APPLICATION NO	PA/2022/956
APPLICANT	Mr Richard Corbet, Balfours LLP
DEVELOPMENT	Planning permission to construct an agricultural irrigation reservoir
LOCATION	Land north of Risby Road, Appleby
PARISH	Roxby cum Risby
WARD	Broughton and Appleby
CASE OFFICER	Tanya Coggon
SUMMARY RECOMMENDATION	Refuse permission
REASONS FOR REFERENCE TO COMMITTEE	Support by Appleby Parish Council

PA/2022/956 Proposed layout (not to scale)

Project Low Risby Reservoir	
Drawing Title New reservoir Scheme design	
Scales 1:500	Sheet Size A1
Drawn N.Hewerdine	Checked Approved Date 15/05/2022
Drawing Number DJS-ES-P470-02	Rev B

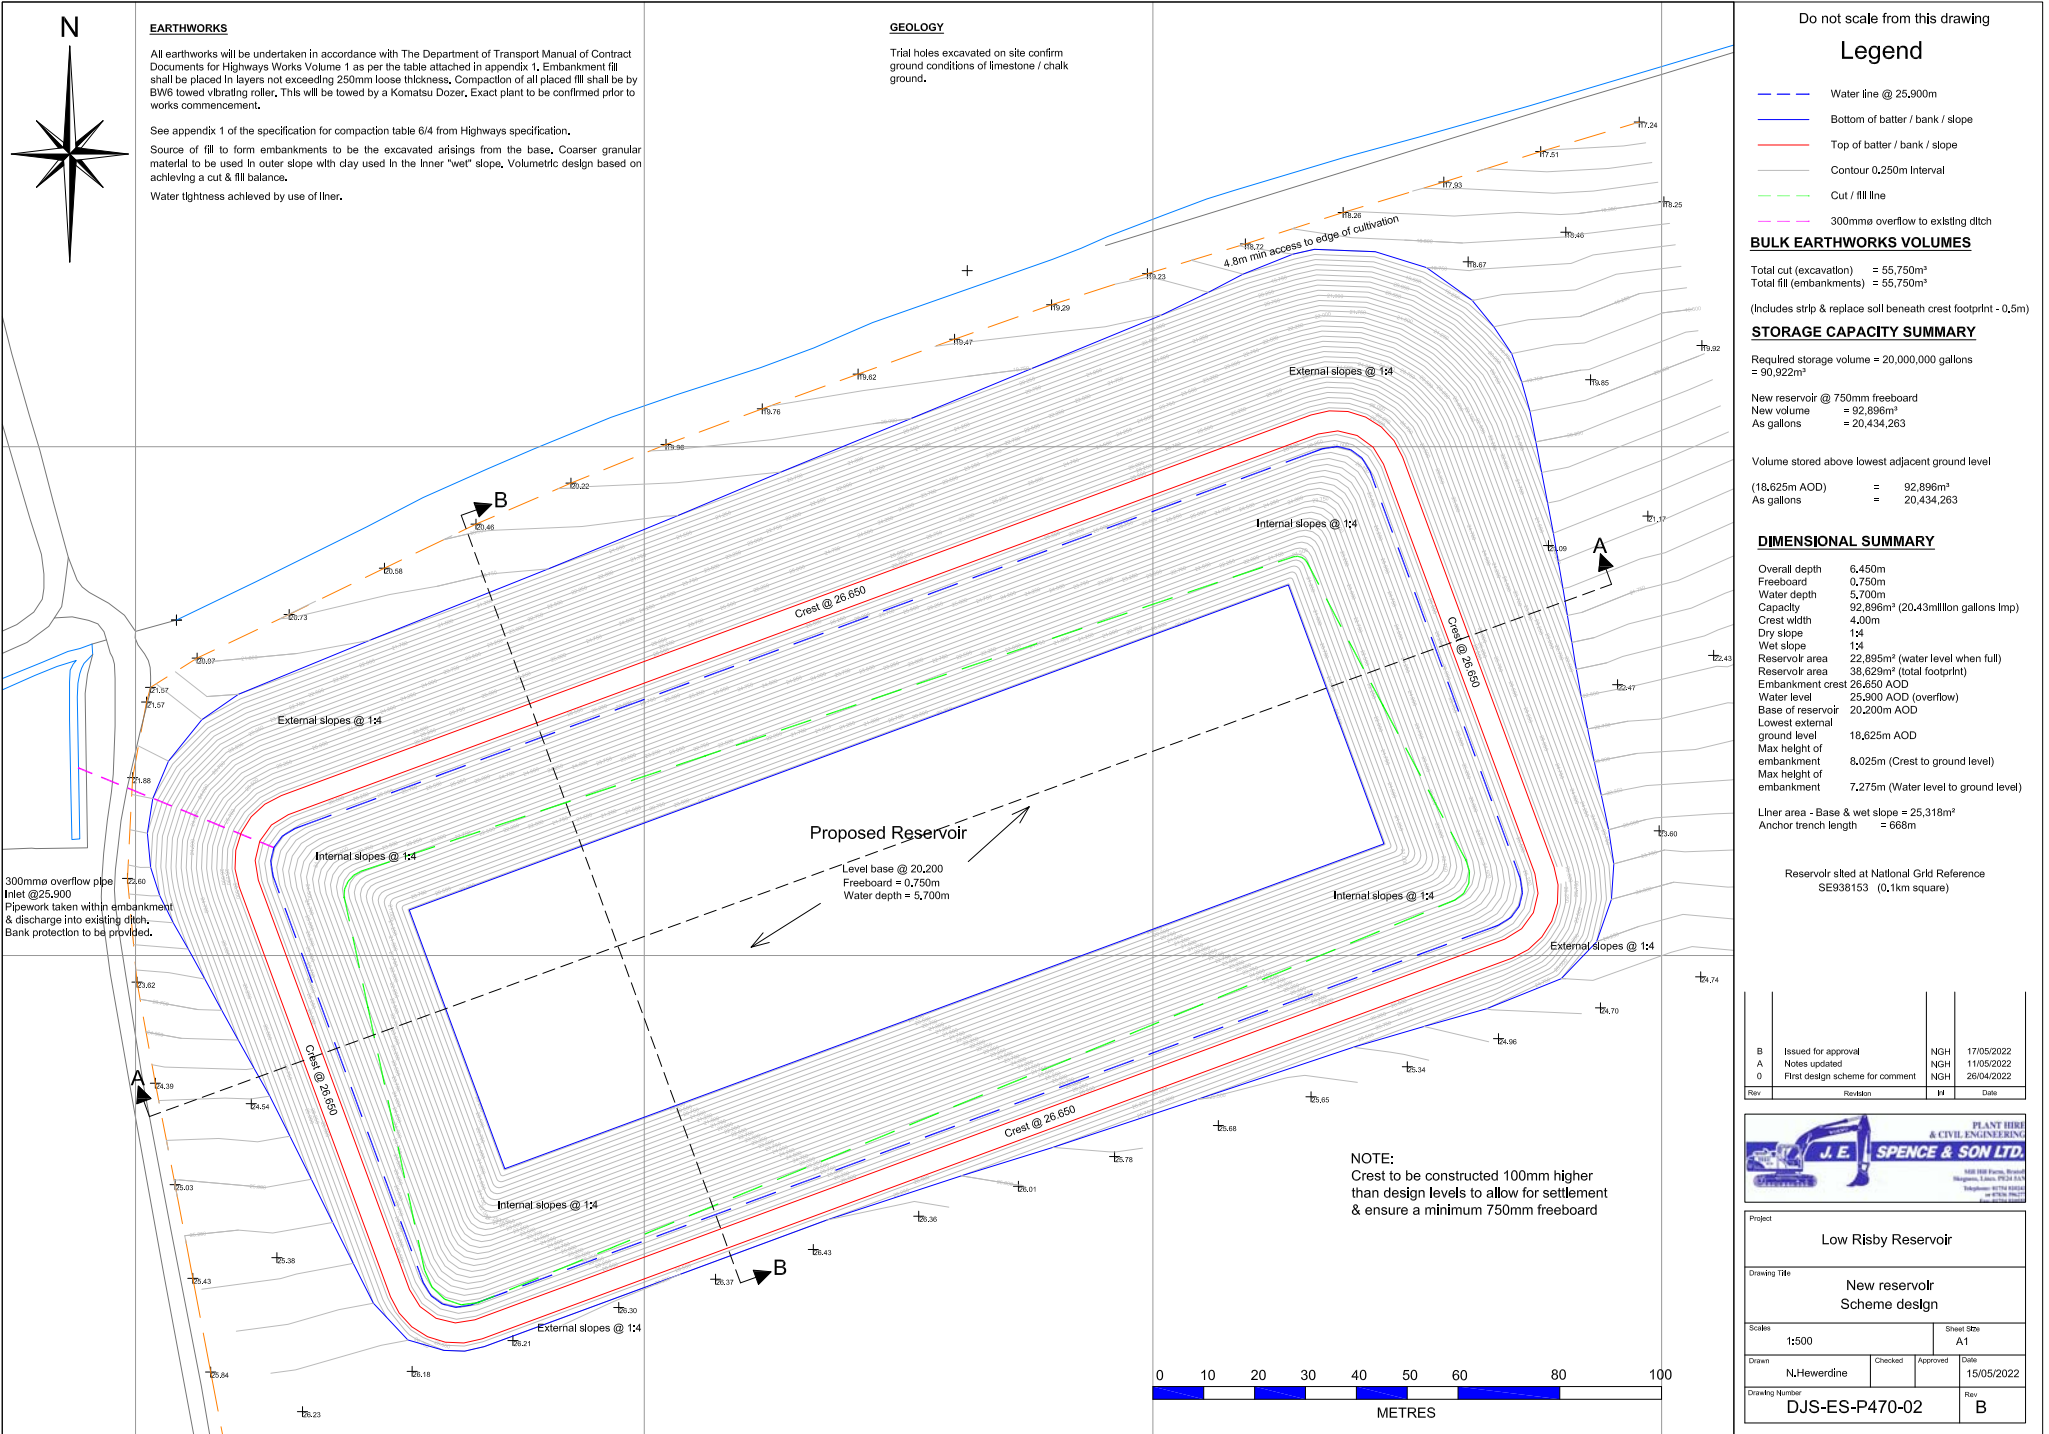
- consider the reservoir overflow on the receiving watercourse. Whilst it is there as an emergency overflow, it still may be used and the impact of additional flows on the receiving watercourse and flood risk must be considered. Will the receiving watercourse be able to accommodate any increase in volume and flow? Will any overflow increase the risk of flooding and possible flood extents downstream?

- consider the failure (breach) of the reservoir and the associated inundation which could impact the surrounding area and third parties downstream. As previously advised and in particular response to Section 5.5 – Reservoir structure and stability, the proposed irrigation reservoir would fall under the Reservoirs Act 1975. The requirements of the Act are more stringent than those of general drainage and water storage structures. Furthermore, additional maintenance and inspection beyond that set out in the SuDS manual are also likely to be required.

approved by them to avoid any abortive work through subsequent required changes to the design (for example, the current design does not include a spillway).

The proposed irrigation reservoir is to be constructed to retain a water level well above the natural level of the ground through the use of raised embankments. Any embankment failure would result in the rapid release of large volumes of stored water downstream of the site with significant flood hazard along the resulting flow path. There is existing development downstream of the proposed reservoir and surrounding area.

Whilst the risk of failure of the raised embankment/reservoir dam breach may be low, the consequence could be significant. The FRA must assess the failure (breach) of the reservoir and the associated inundation which could impact the surrounding area and third parties downstream. We would welcome further discussions on any modelling/breach analysis proposed.
